**In Response to CURE Requests 1-143
Application for Certification (08-AFC-5)
SES Solar Two, LLC**

08-AFC-5

Subject: SES Solar Two (08-AFC-5)
Responses to CURE Data Requests 1-143
URS Project No. 27657106.00400

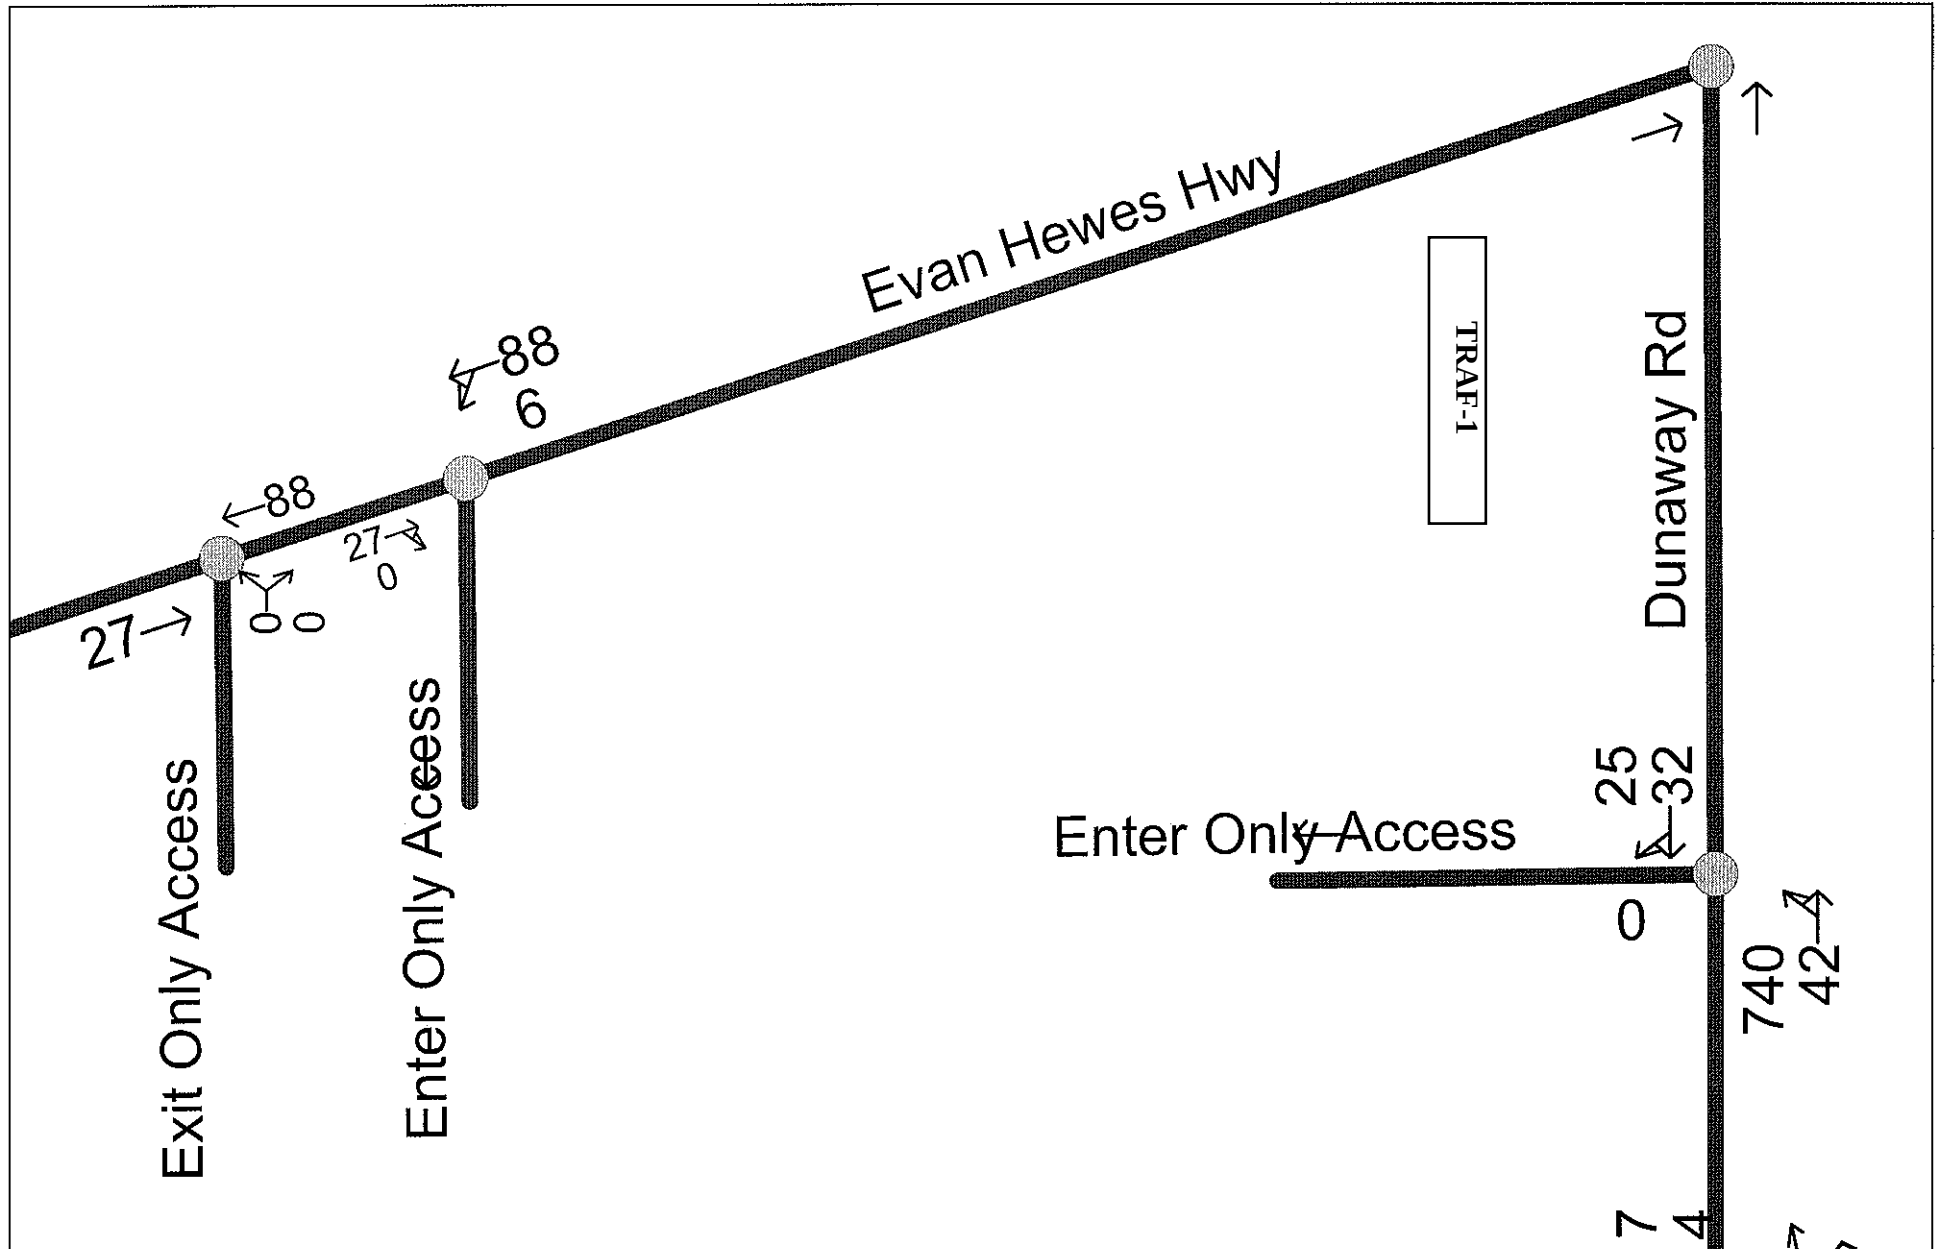
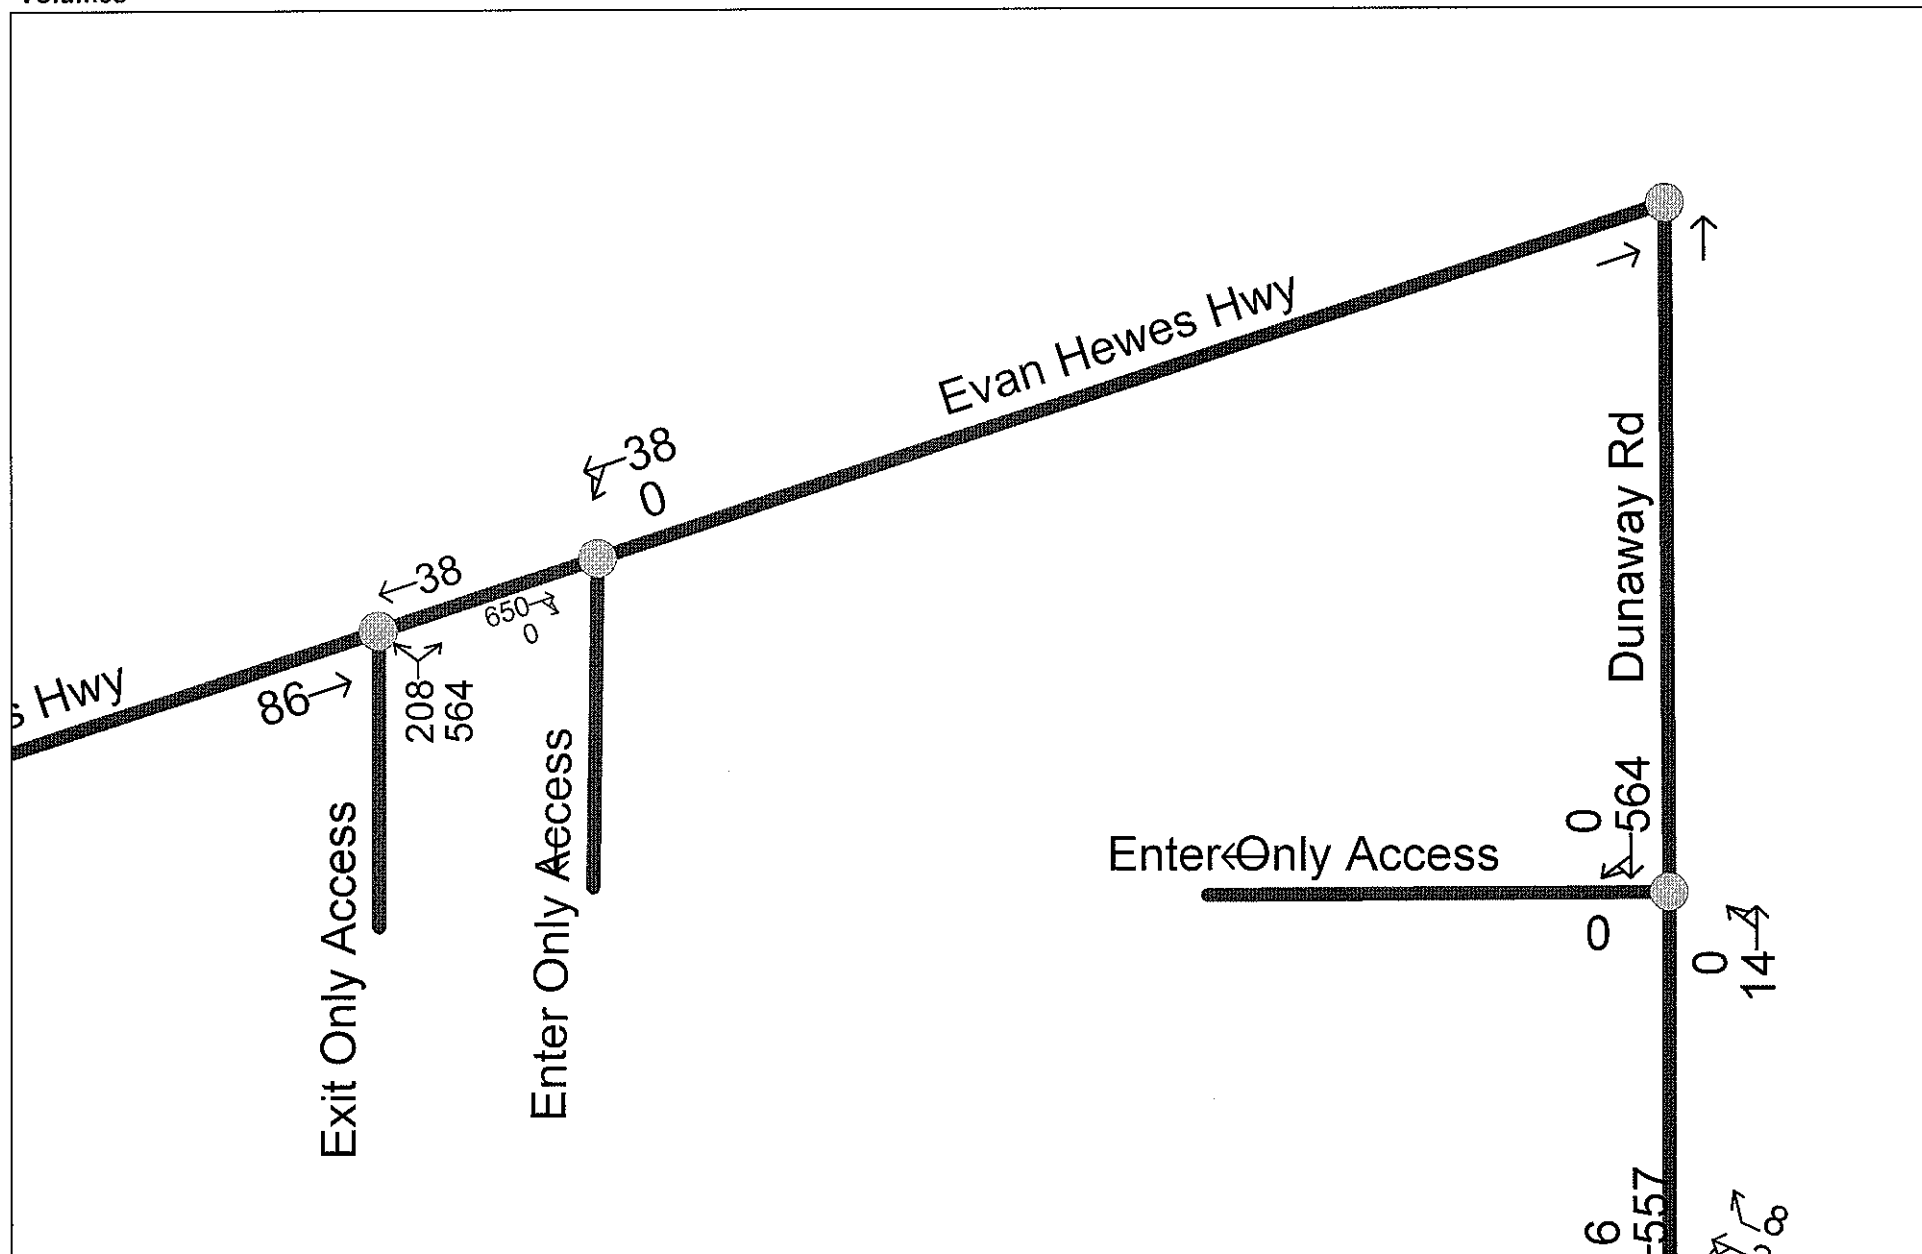
Data Request 1: Please provide additional information regarding the location of parking for construction workers and explain how construction worker traffic will enter and exit the Project Site.

Response: A temporary construction parking lot for Phase I will be located on previously disturbed land within the Phase II area. This lot is located west of the main site access road off the Evans Hewes Highway entrance and south of the north property line. Phase II will utilize the Dunaway Road yard site for construction parking.

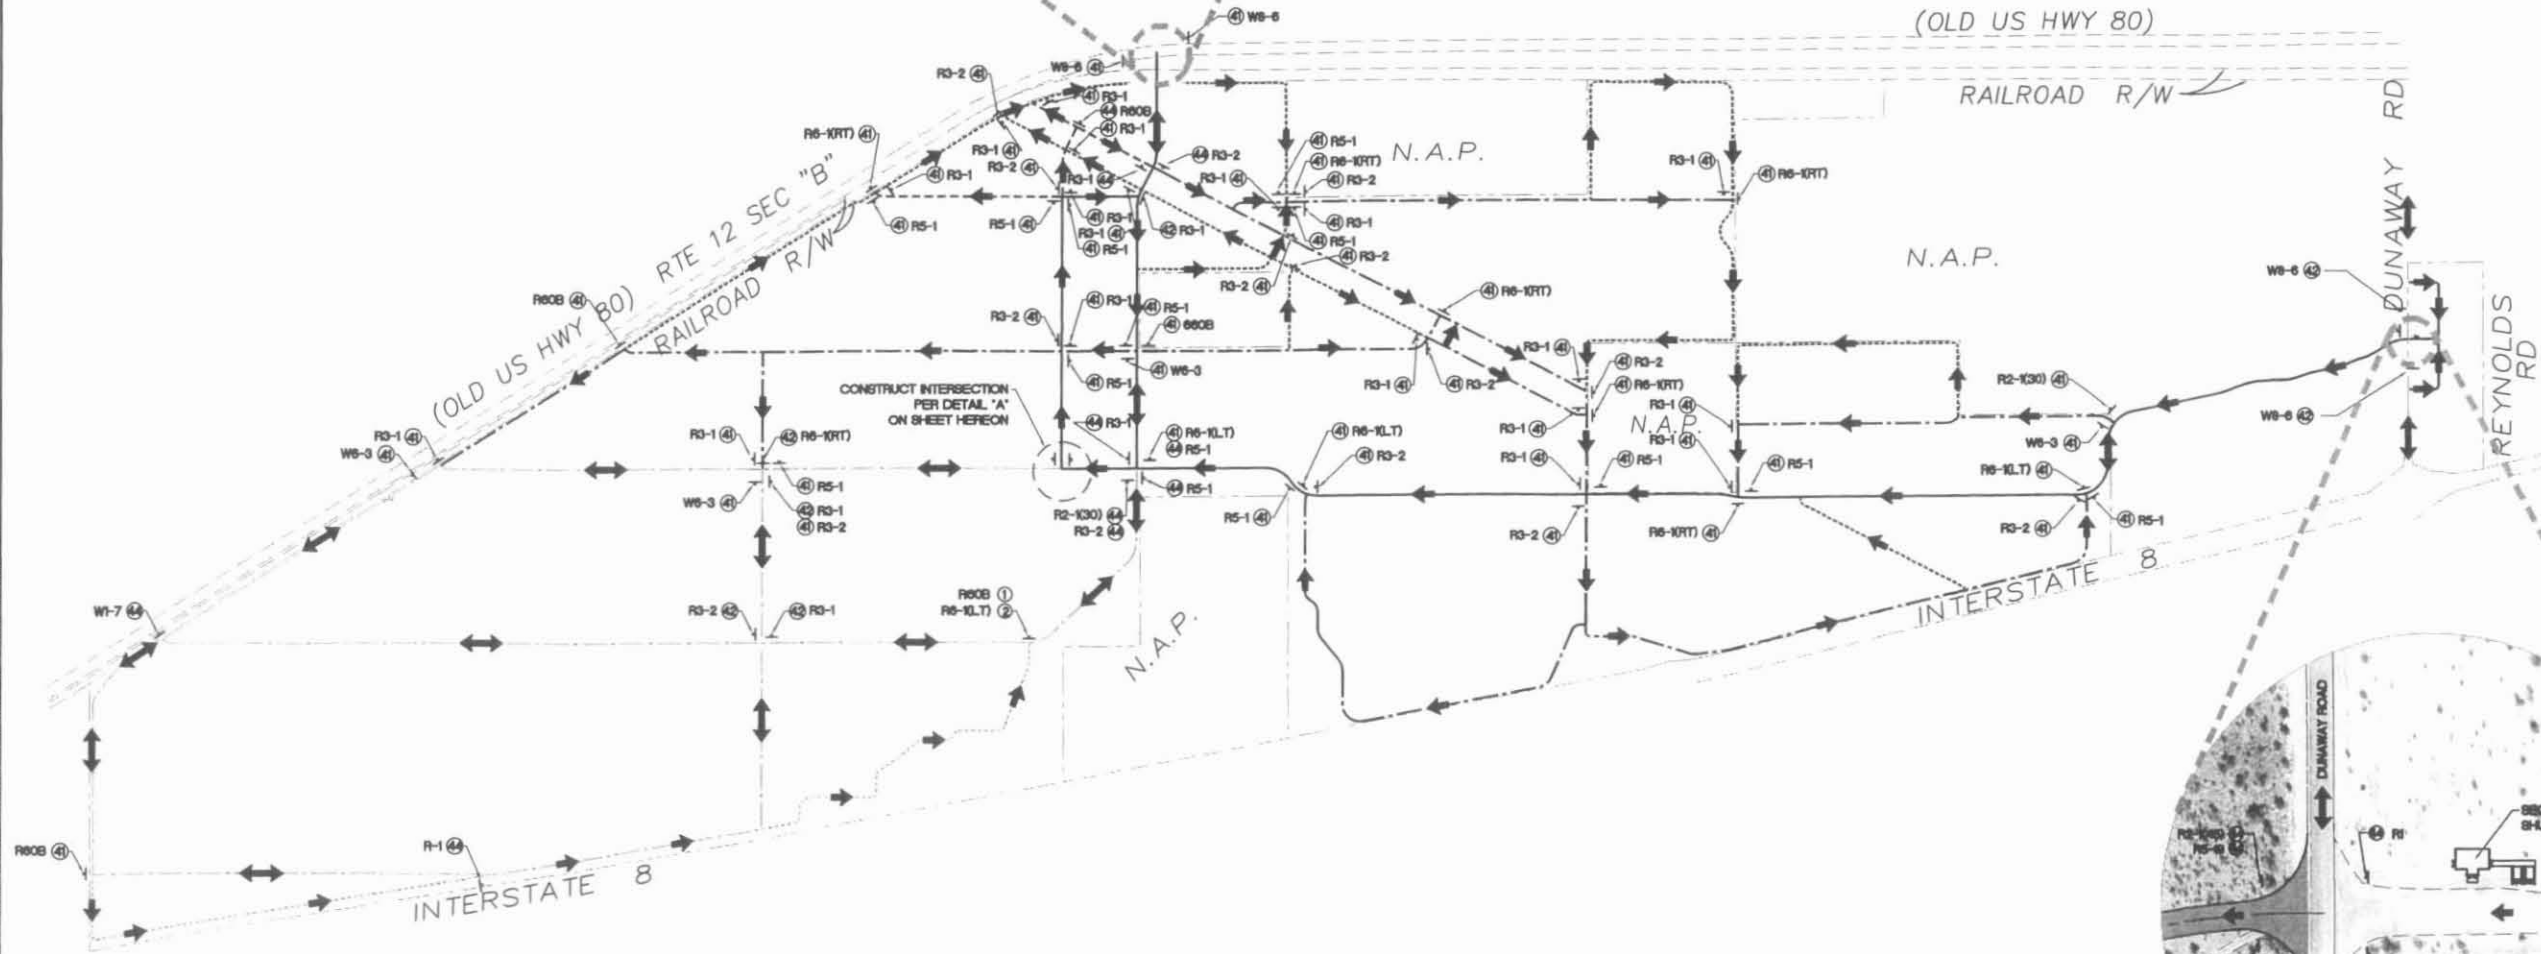
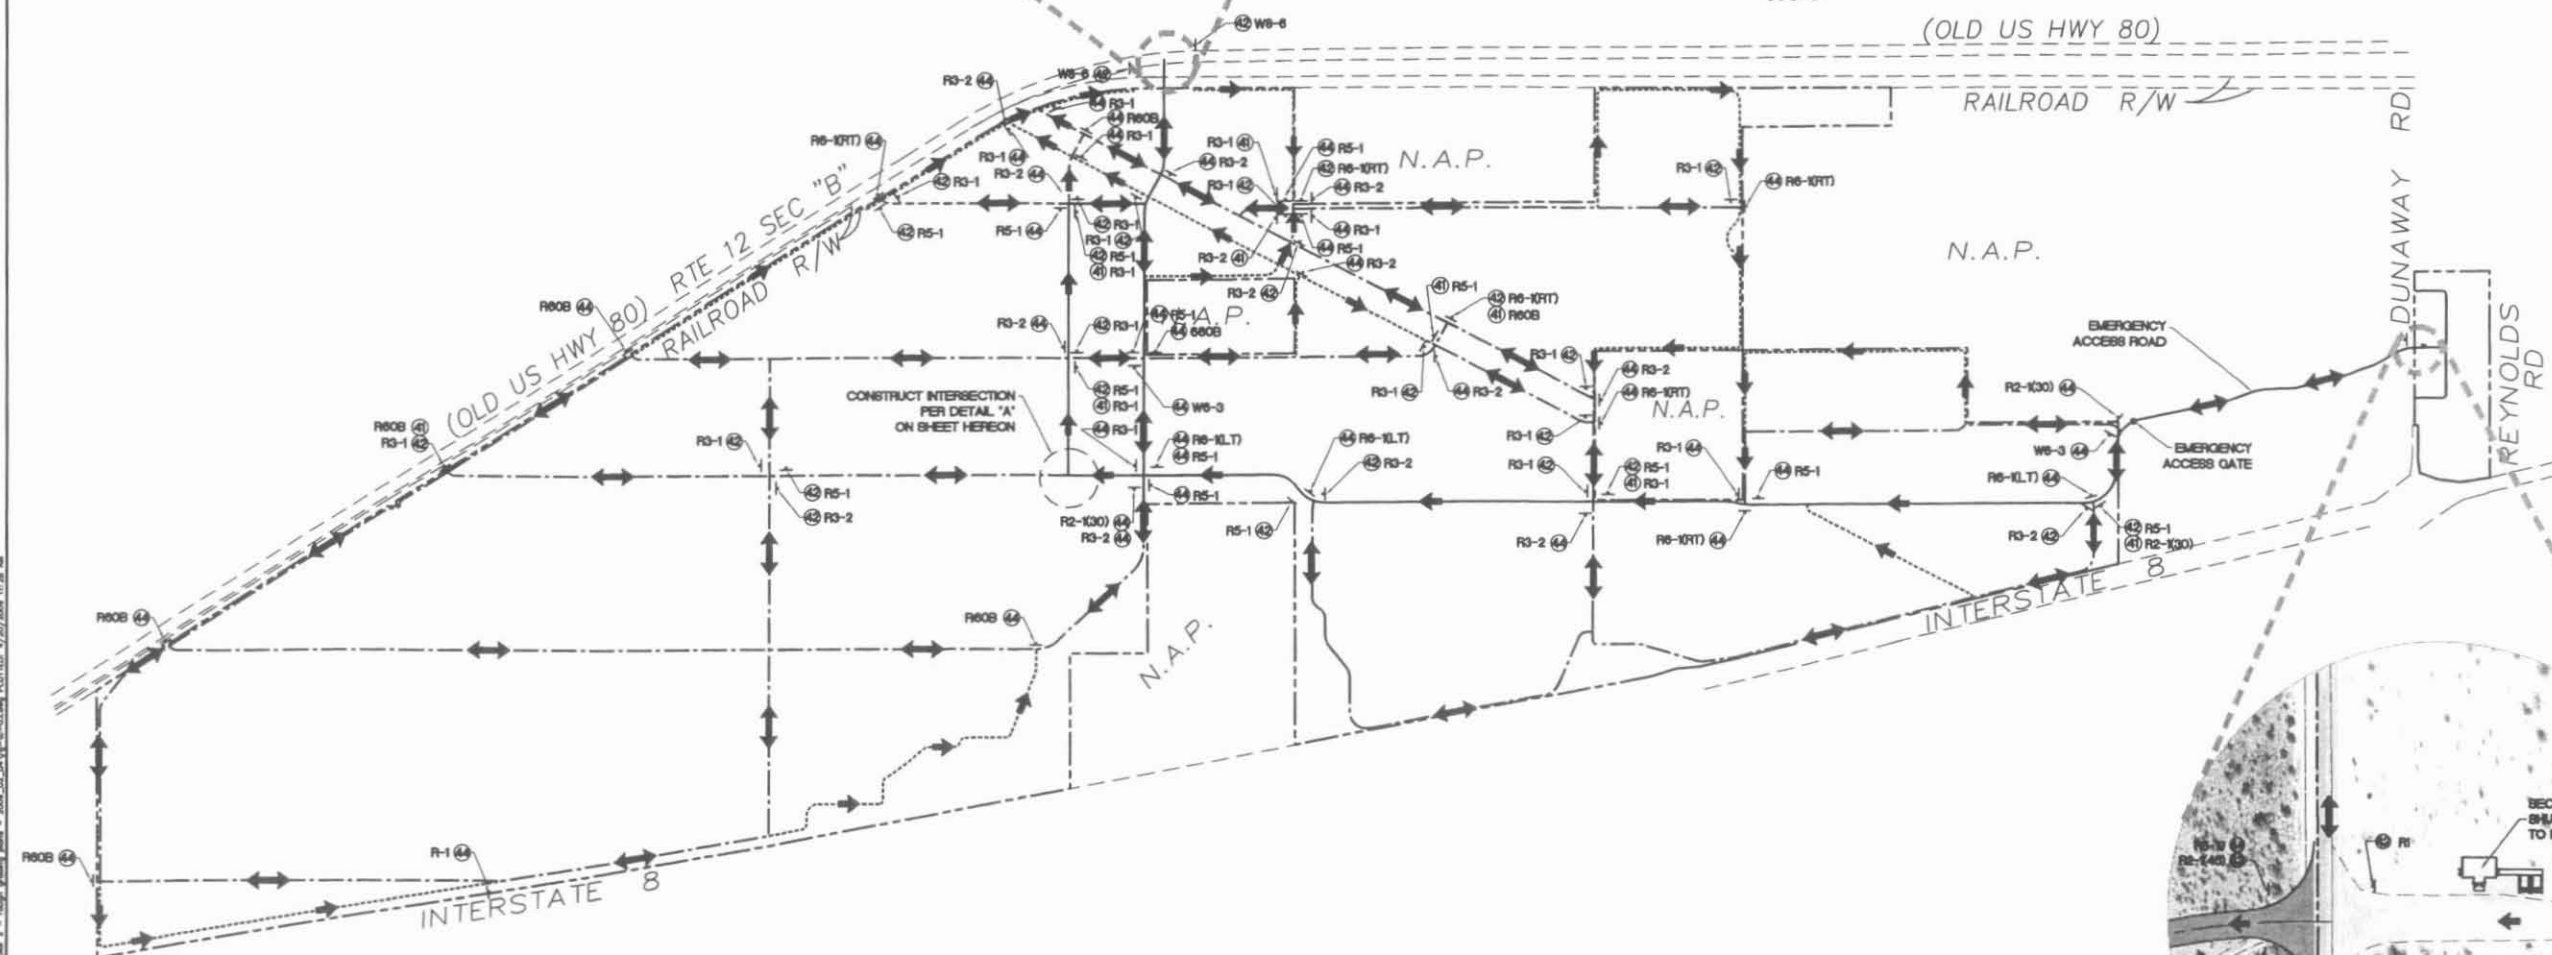
Data Request 5: Please identify the level of traffic control that will be required to provide safe traffic conditions at both primary access driveways during Phase I and II of construction, as well as during post construction operating conditions.

Data Request 7: Please provide plans showing traffic flow and traffic signing for both of the construction phases and for post construction operating conditions.

Response: Traffic control will be primarily in the form of signage and striping and delineation lines and painted pavement markings. The Traffic Control Plan (attachment TRAF-3 provided behind this response) shows the proposed traffic control during both phases of project construction and during post construction operating conditions.

Response: The Traffic Control Plan (attachment TRAF-3) show the proposed traffic flow and signing during both phases of project construction and during post construction operating conditions.
